## CONFLUENCE QUESTIONS & COMMENTS

SPU received many comments from the public regarding the 60% design of the Thornton Creek Confluence Improvement project throughout August. A compilation of those questions and comments is here.

60% DRAWINGS

THORNTON CREEK CONFLUENCE

GRADING WEST THORNTON CREEK

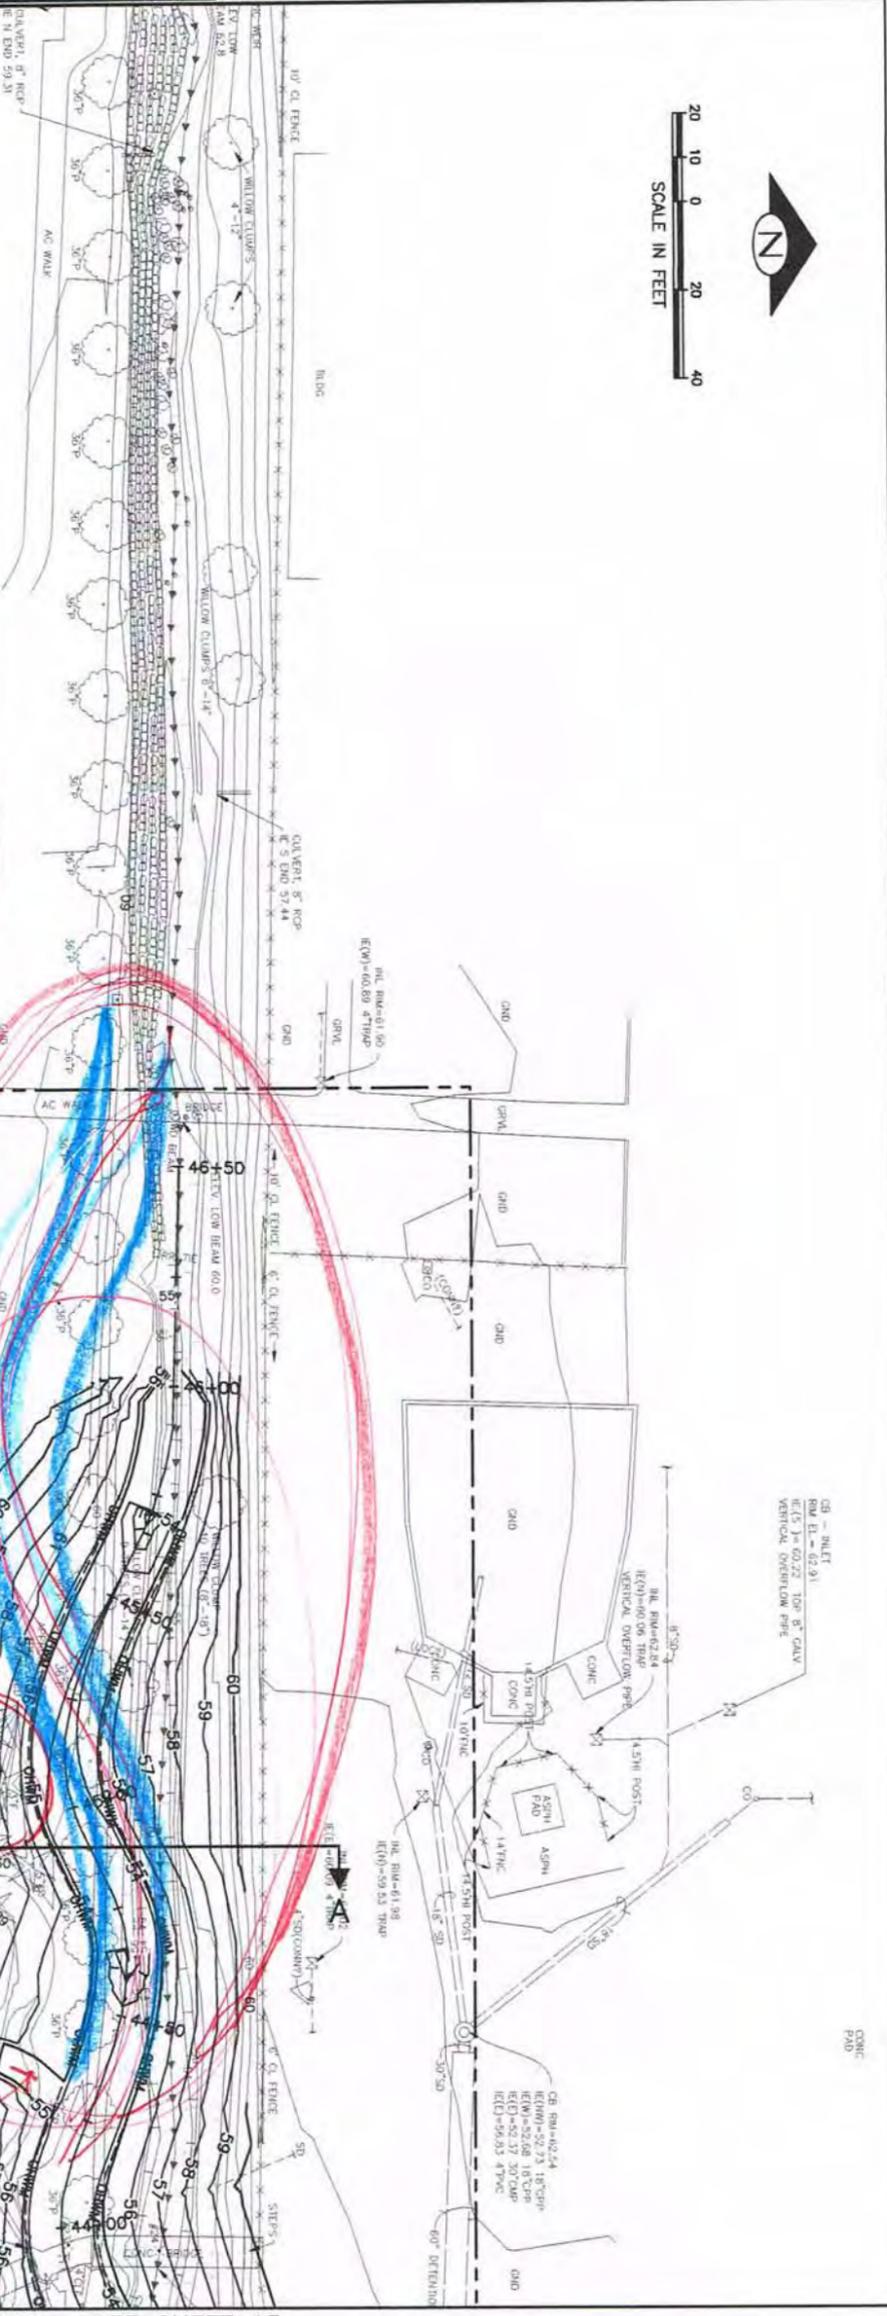
Is Parks reviewing?

NOTE: side channel "Meadowbrook Creeklet" was built by a volunteer group - Funding. Design by Skymor, Inc. this end complete in 1997.

NEED: Start meanders & further west & save more of Meadowbrook Creeklet & planting rows 15-16 yrs old & planting of credit roads. Considered Meadowbrook sensitive areas. VEG 8/30/12

STAKE PLANTS - MAKE MORE CAUTION & credit " "

Prepare for Meadowbrook creeklet?

REMOVING/REPAIRING EX. RED BRANES?

FOR SENSITIVE? - WDG INTERFERED TO BE -

DEEP & STEEP. POSSIBLE IN THIS LIMITED CAPACITY. HOW RESTRICTIONS SIDE SLOPES? VEG? DATE?

PC C408023  
 R/W  
 W/VT PLAN NO. 777-705  
 SHEET 13 OF 51

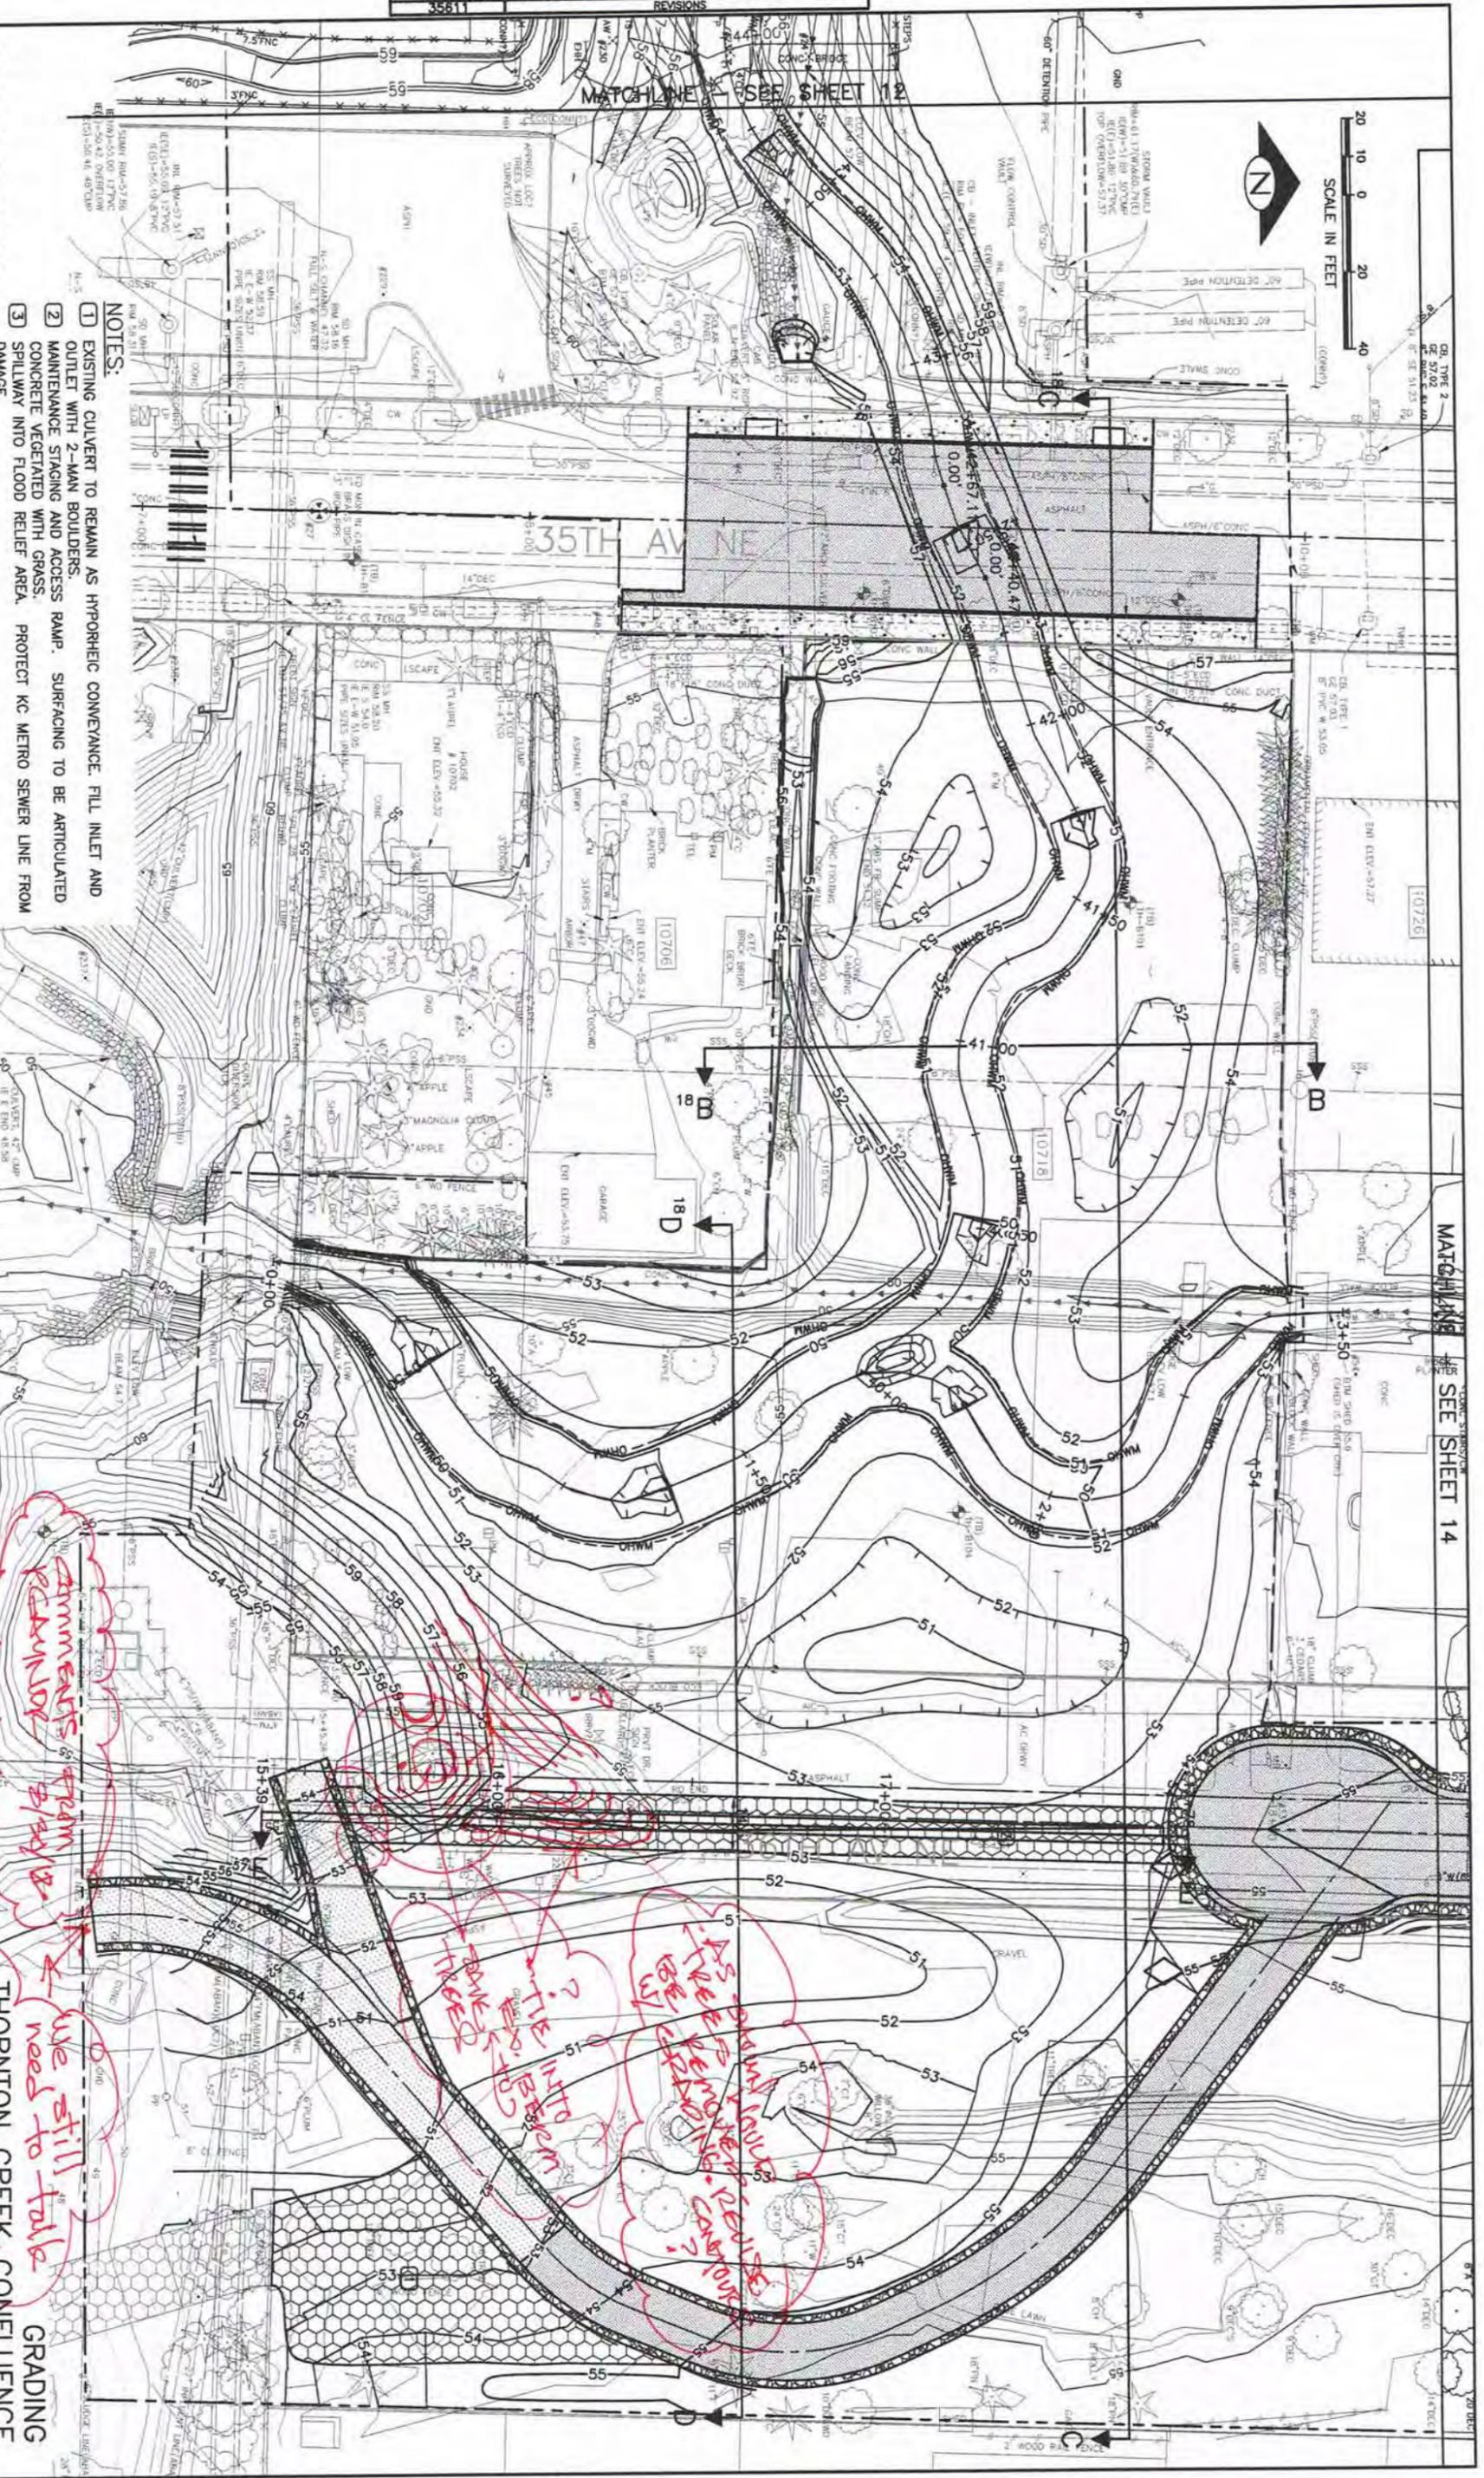
*Comments & Plan Review 8/15/12*

*use still to talk about maint. needs to talk access to Pond*

*THE EXISTING CONTOUR...  
 INTO RESERVATION...  
 NEEDS TO BE...  
 THE EXISTING CONTOUR...*

PC C408023  
 R/W  
 VULT PLAN NO. 777-705  
 SHEET 14 OF 51

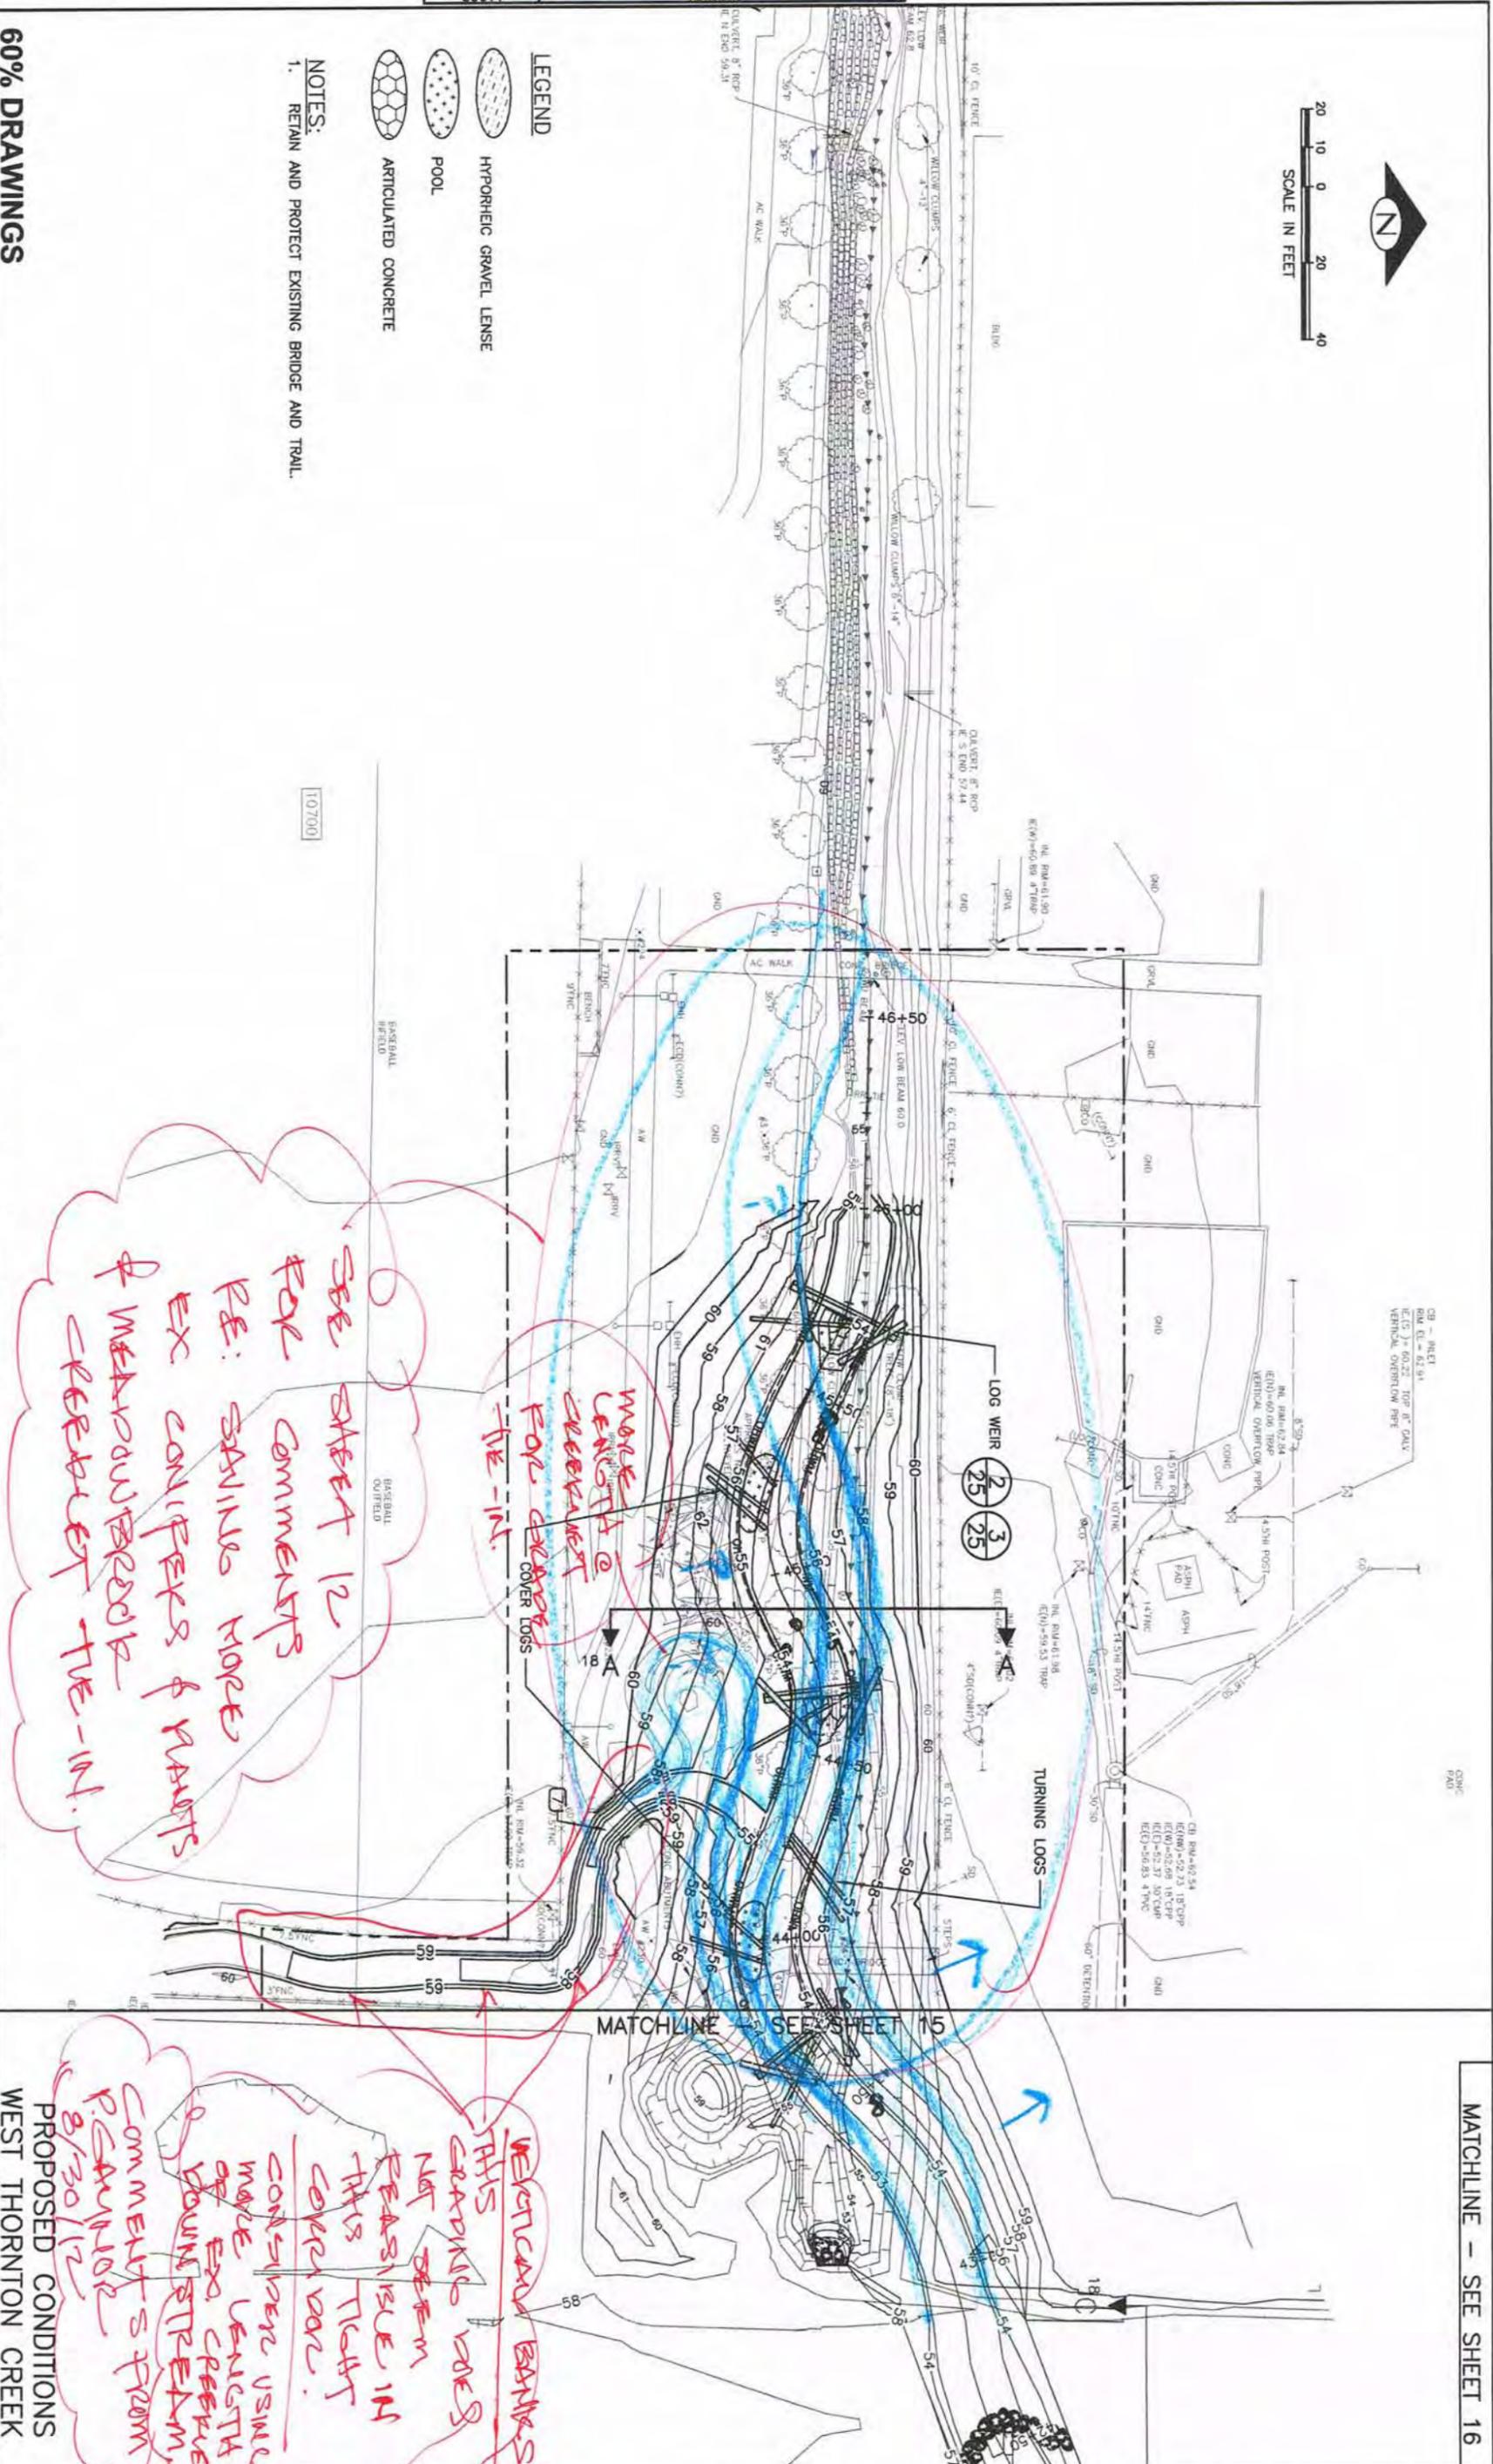
*SEE SHEET 12 FOR COMMENTS RE: SWIMMING MORE EX CONIFERS & ROOTS REFER TO THE -IN.*

*VERTICAL BANKS? THIS GRABBLE DOES NOT SEEM FEASIBLE IN THIS TIGHT CORNER. CONSIDER USING MORE LENGTH OF EXO CURVE AT DOWNSTREAM. COMMENT FROM 8/30/12*
